NPL 2000-0341

DOCKETS 50-266 AND 50-301
SUPPLEMENT 4 TO APPLICATION FOR AMENDMENT TO
FACILITY OPERATING LICENSE APPENDIX A:
TECHNICAL SPECIFICATIONS IMPROVEMENT PROJECT
RESPONSE TO RAI ON ITS SECTION 3.8
POINT BEACH NUCLEAR PLANT, UNITS 1 AND 2

DOCKETS 50-266 AND 50-301
RESPONSE TO REQUEST FOR ADDITIONAL INFORMATION
TECHNICAL SPECIFICATIONS IMPROVEMENT PROJECT SECTION 3.8
POINT BEACH NUCLEAR PLANT UNITS 1 AND 2

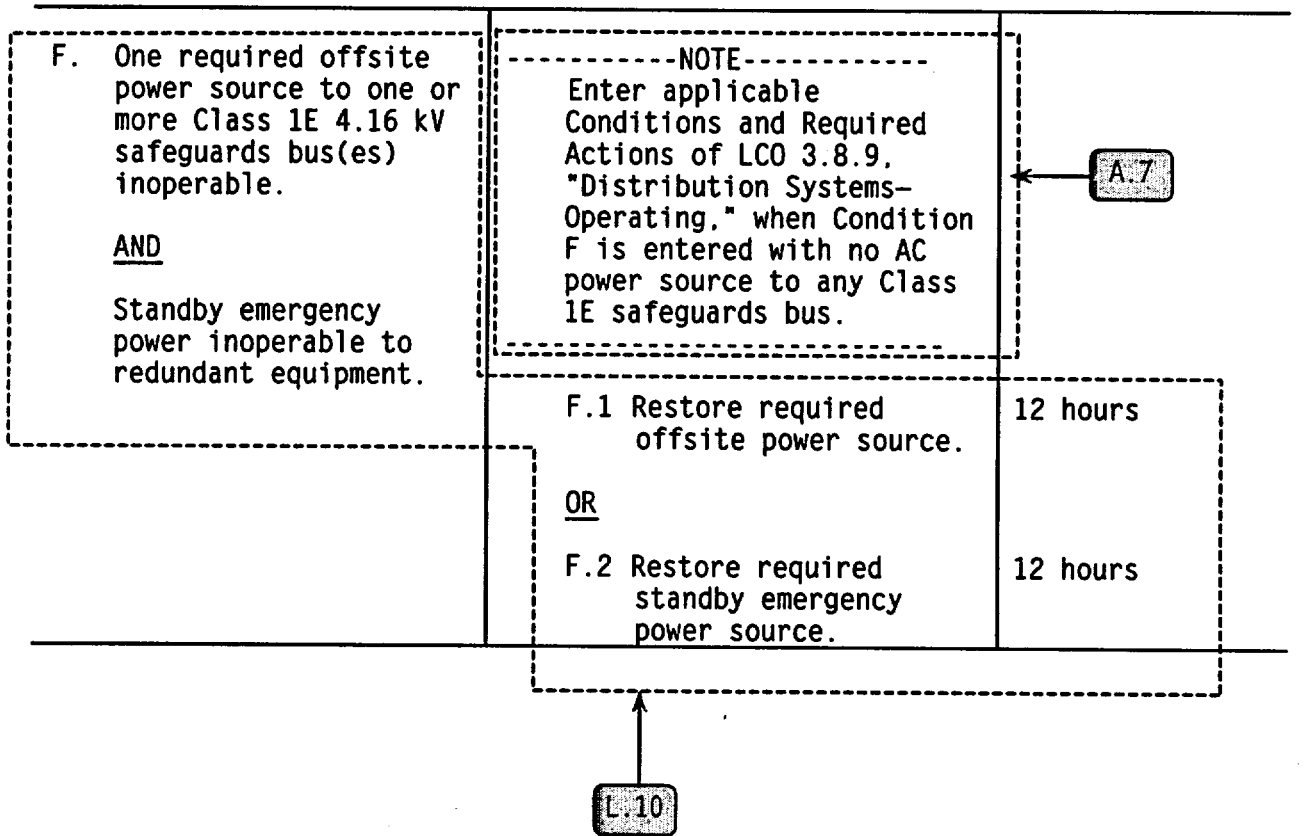
The proposed ITS includes LCO 3.8.1, Condition C. This condition would allow buses A05 and A06 in the same unit, or buses 1A05 and 2A06 to be without offsite power for 24 hours. Neither of these plant conditions is allowed by the CTS, and represent a less restrictive change. It is the staff's view that the DOCs associated with this change do not provide an adequate justification for the change. The justifications provided paraphrase the NUREG Bases, but fail to address why the change is acceptable from a plant-risk perspective. The licensee is requested to revisit the proposed change with a view towards providing a more adequate justification.

DOC L.06 has been revised to include a more complete discussion of the acceptability of the proposed ITS Condition C allowed outage time from a risk perspective. The time proposed for restoration of the offsite source of power is sufficient to restore offsite power in most cases while short enough to account for the importance of the offsite, preferred power source. During this condition, onsite sources of power are not affected such that the safety function of all required equipment will continue to be performed. The allowed outage time recognizes the most likely causes for the inoperability of offsite power are related to problems with the offsite power grid. In these cases, removing a unit's generation from the grid may further exacerbate the condition, making it more difficult, and take a longer time, to restore offsite power thus further impacting the operability of required onsite systems. Thus, 24 hours is a reasonable time to correct the condition.

B
RAI 3.8.1-9

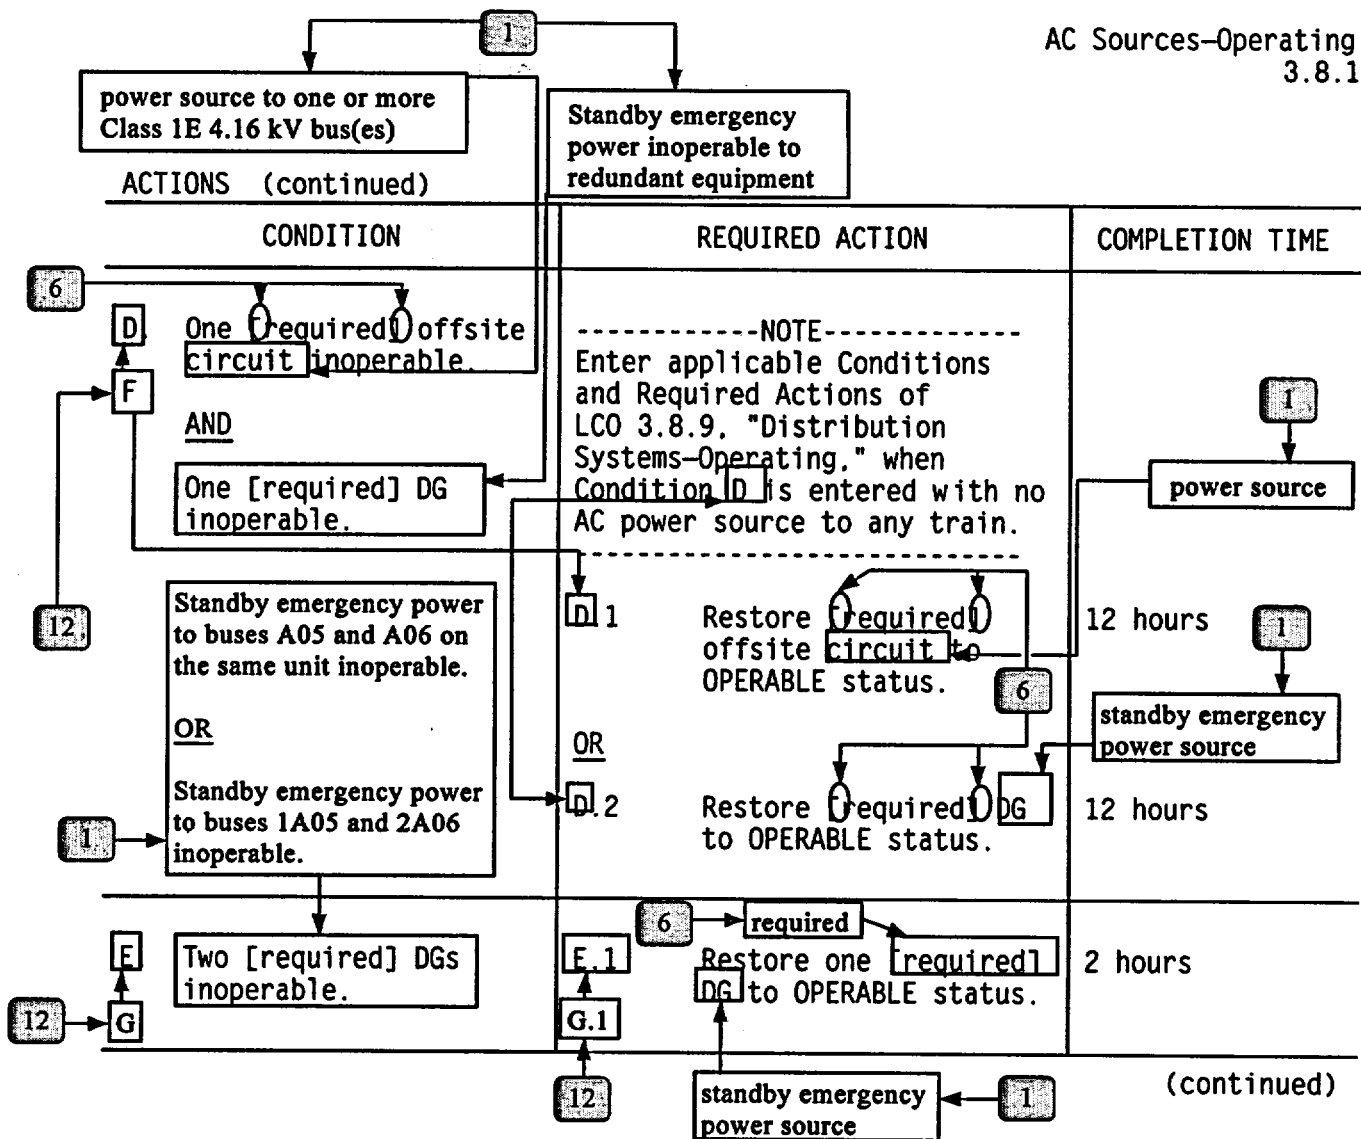
Required Actions A.1 and A.2 address the opposite unit's X03 transformer and the gas turbine, respectively. This appears to be redundant to the LCO, since the plant condition addressed in Actions A.1 and A.2 is specifically allowed by the LCO. This is potentially confusing. Consideration should be given to revising the LCO to be consistent with the Bases discussion as the normal power alignment, and the allowed alternate alignment addressed in Required Actions A.1 and A.2.
